Parking Assessment Site Redevelopment – Proposed Housing 553-559 Islington Street Portsmouth, NH

#### RE: Request for Site Plan Approval at 553 – 559 Islington Street, Tax Map 157 / Lot 3

# PROPOSED REDEVELOPMENT 553-559 ISLINGTON STREET PORTSMOUTH, NEW HAMPSHIRE PERMIT PLANS

SITE LAYOUT PLAN

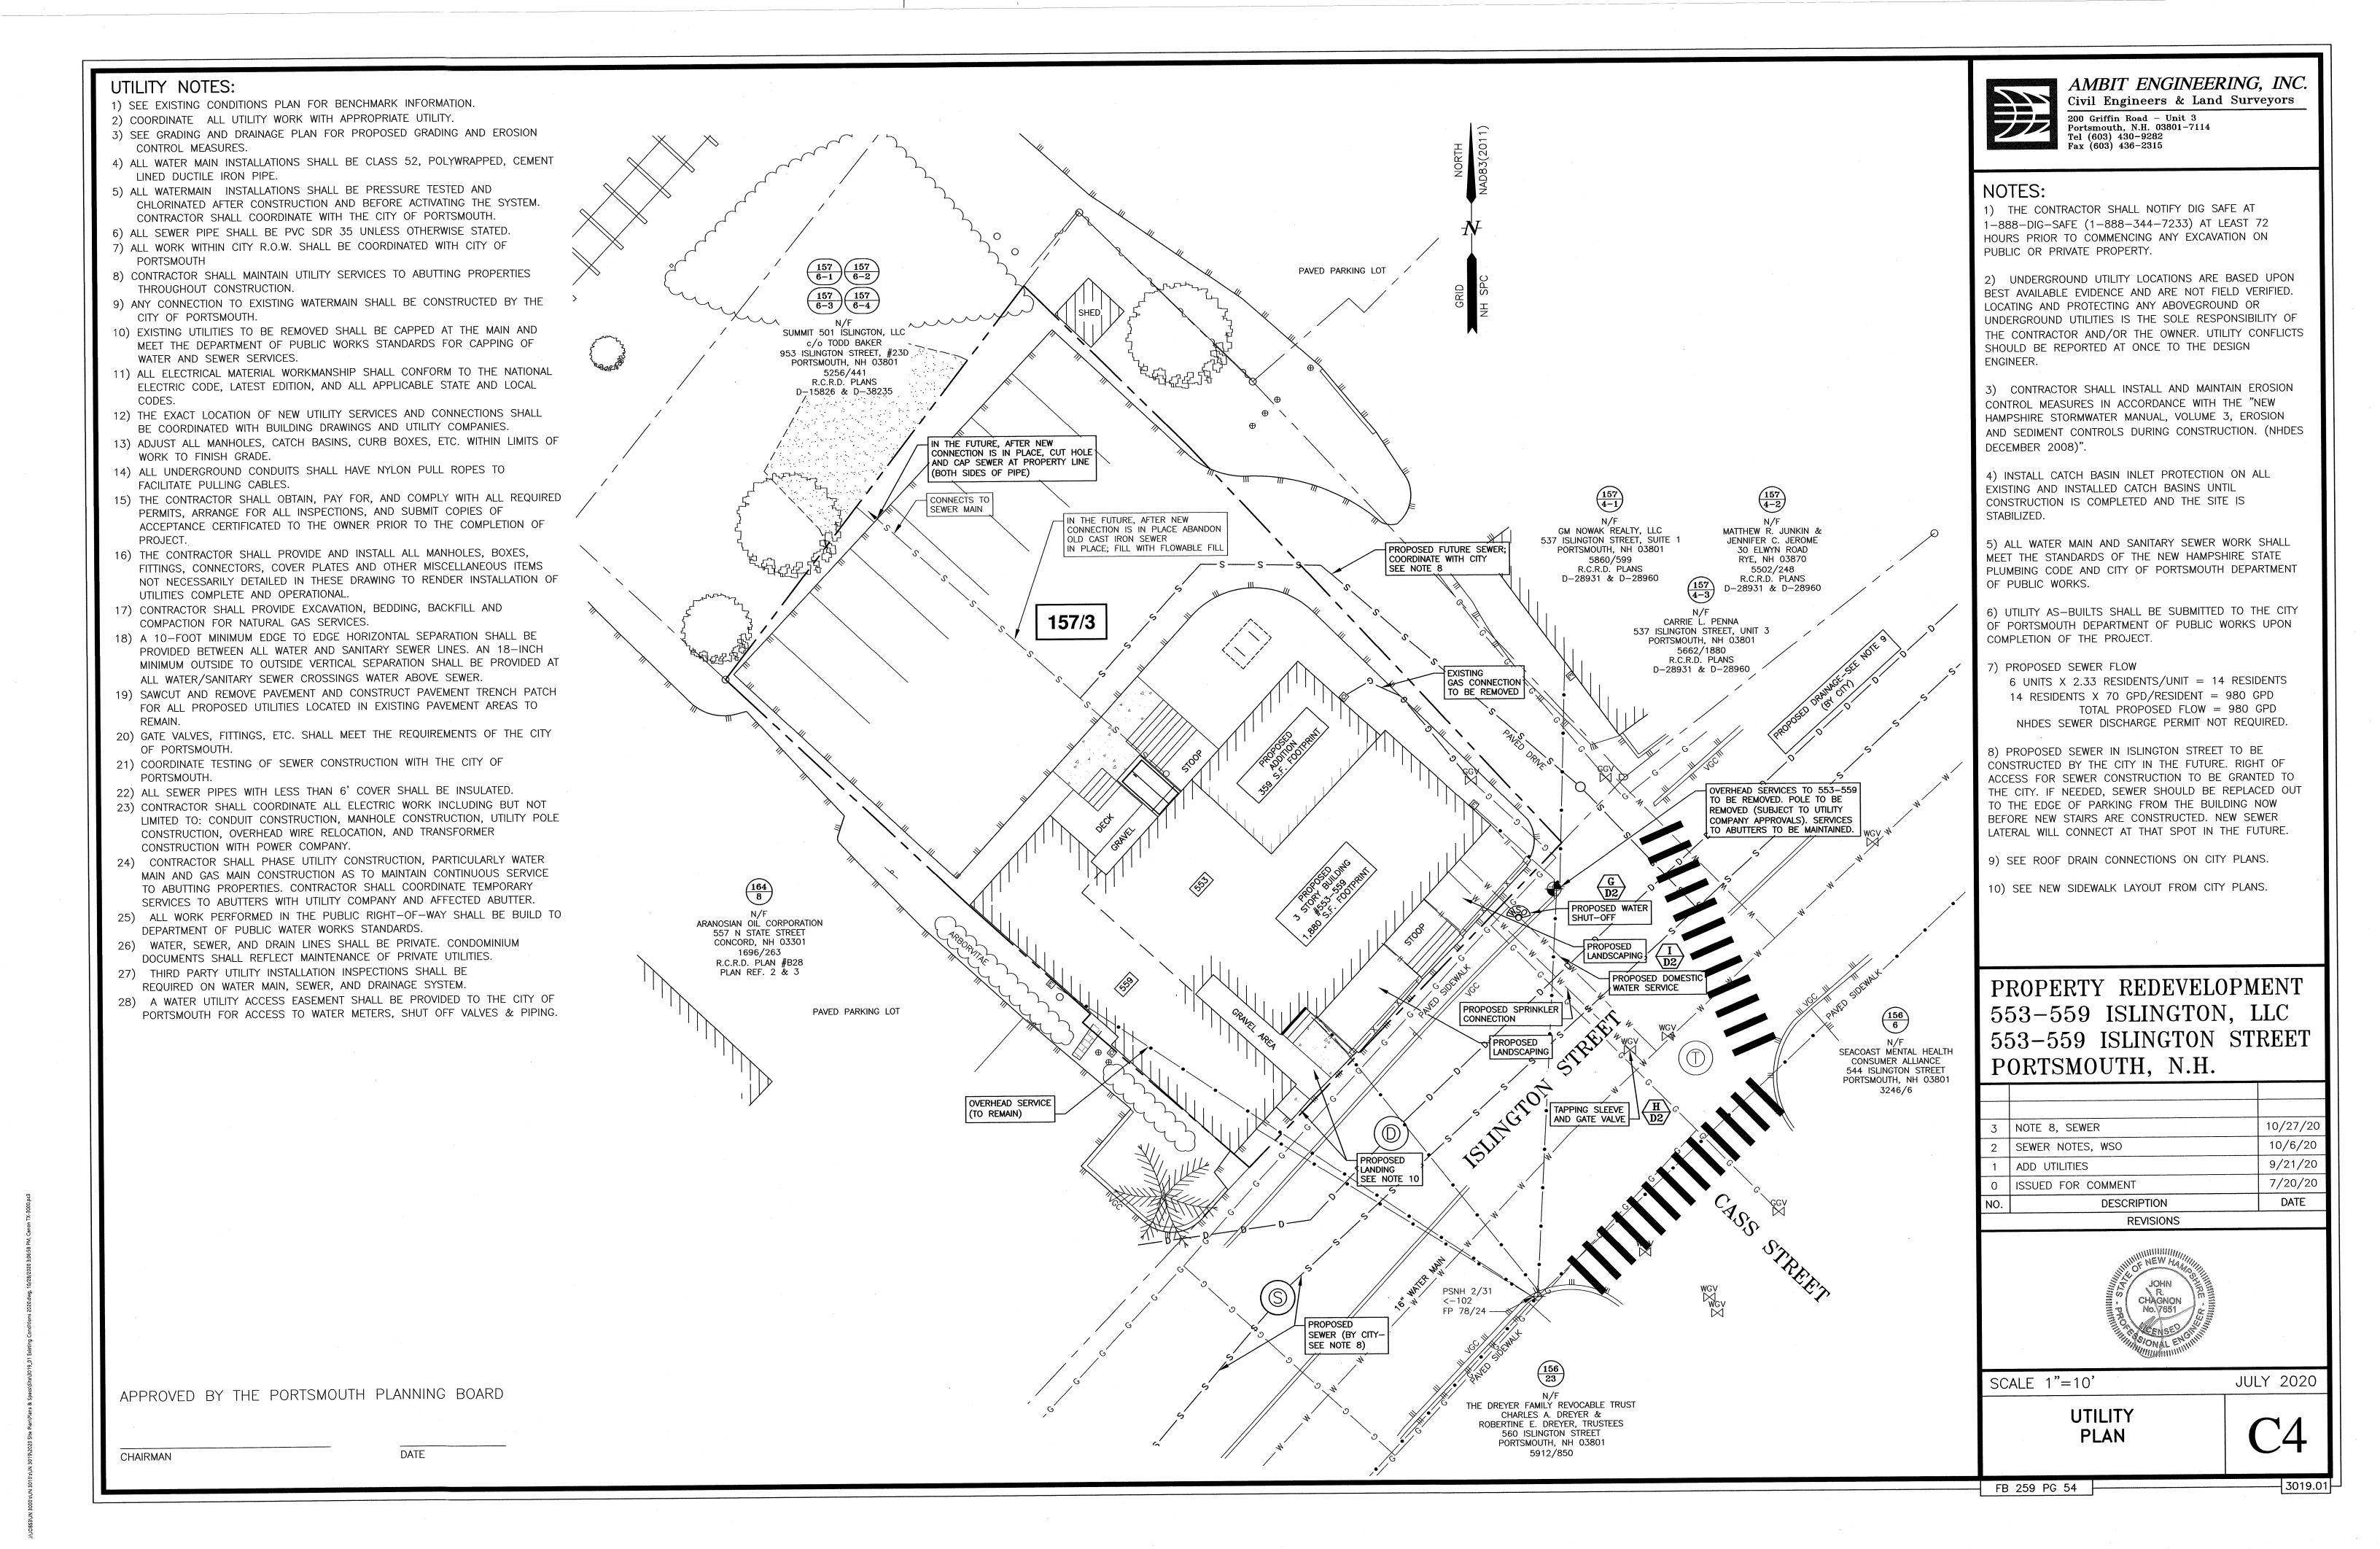
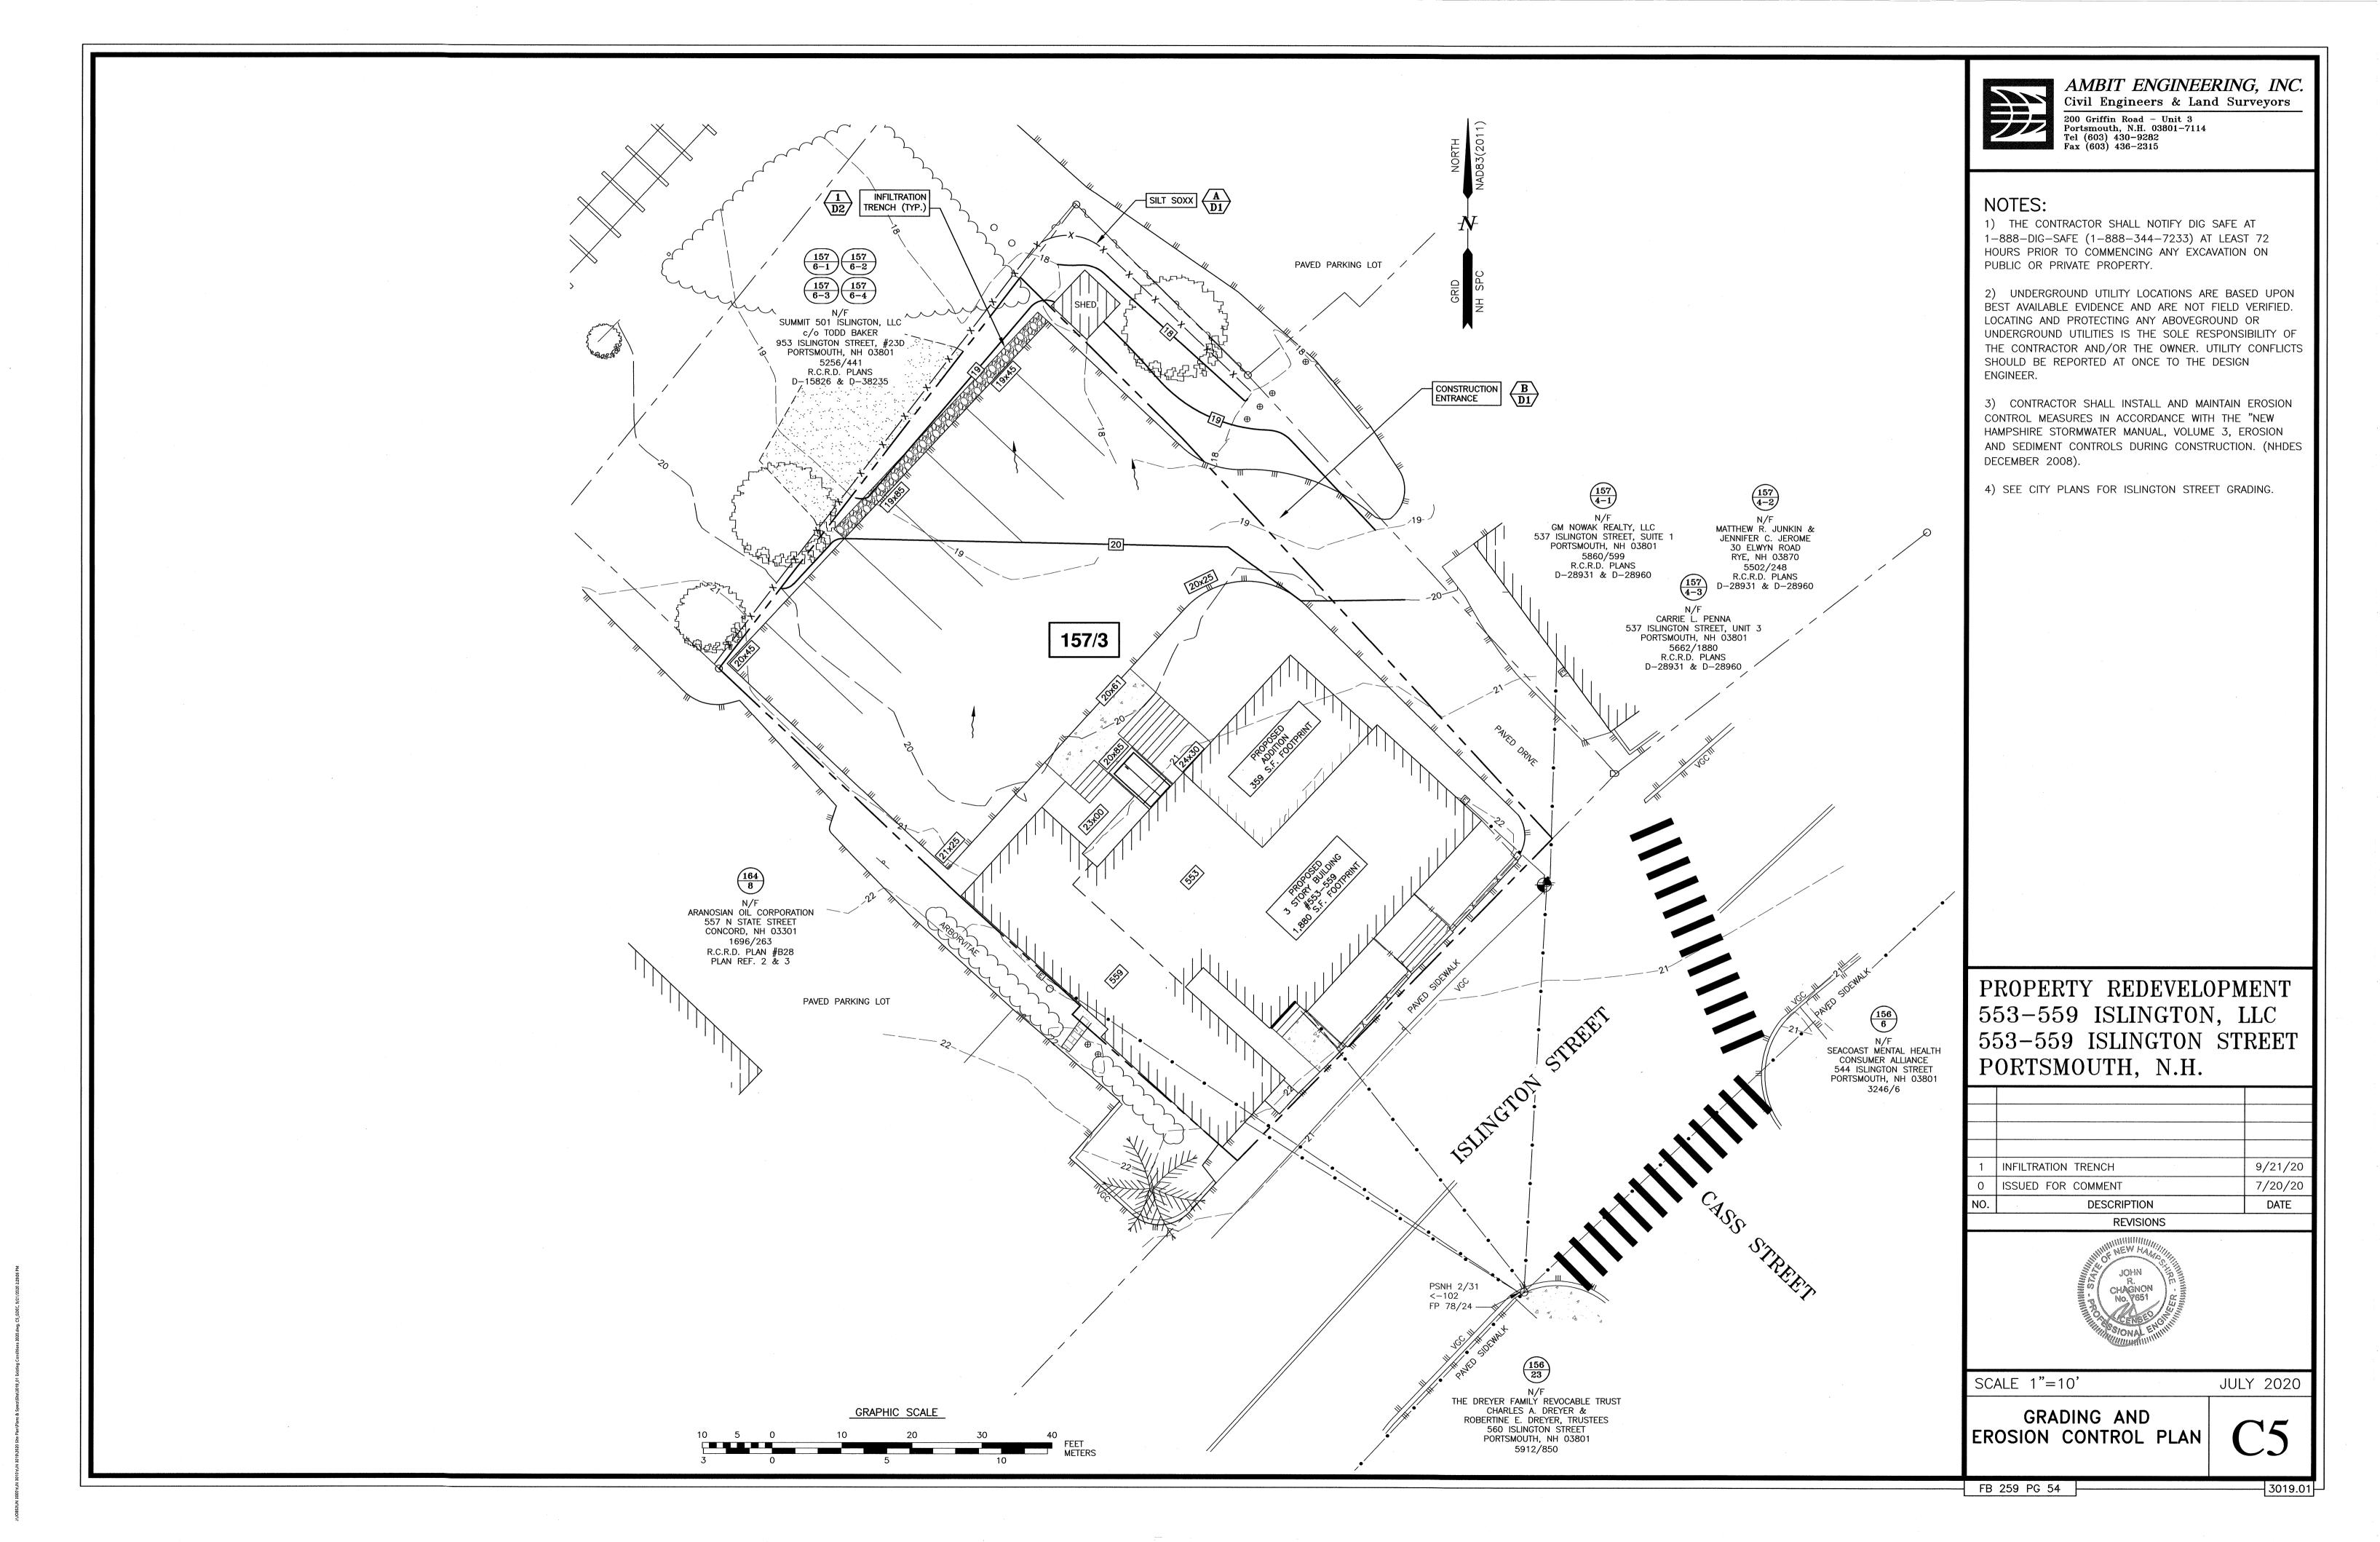
- 1. The sewer shown on this plan 'by the City' will not happen prior to this project. Do not flow fill the existing sewer. It is ok to show a future sewer line and 'coordinate with the City' in the future. Right of access for the future installation of this line by the City should be acquired during this process. If needed, sewer should be replaced out to the edge of parking from the building now before new stairs are constructed. New sewer lateral will connect at that spot in the future. Notes to clarify this are on Sheet C4 as Note 8. The plan notes the right of access shall be granted to the city, also see Note 13 on Sheet C3. The plan notes construction of the lateral for the *future* connection.

- 2. A temporary construction easement shall be provided to the City for future installation of sewer line and the plan shall be updated to note the required easement. The plan notes the right of access shall be granted to the city, also see Note 13 on Sheet C3.

13) CITY TO BE GRANTED RIGHT OF ACCESS AND TEMPORARY CONSTRUCTION EASEMENT TO CONNECT FUTURE SEWER SERVICE ACROSS LOT AND EASEMENT AREA.
